UNITED STATES PATENT AND TRADEMARK OFFICE

10/598,782

Office Action Summary	Application No. 10/598,782	Applicant(s) PARK ET AL.	
	Examiner Krishnan S. Menon	Art Unit 1797

DETAILED ACTION

Fig. 2

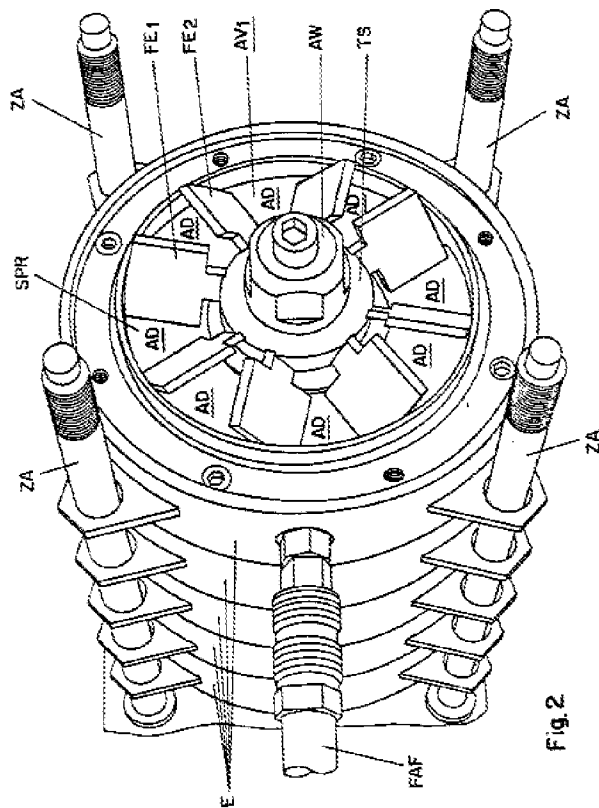
Hug teaches plural sets of blades attached on shaft AW, with a filter tray located between each two sets of blades – see the figures copied above.

There is no requirement that the blades of each set of blades must be oriented in any specific direction/location with respect to its adjacent sets of blades. Thus the blades can be relatively overlapping and/or offset. Claim 1 requires only one filter tray and one rotor. One could have several of this arrangement of rotor and filter trays in a barrel as contemplated by the broadest reasonable interpretation of claim 1.
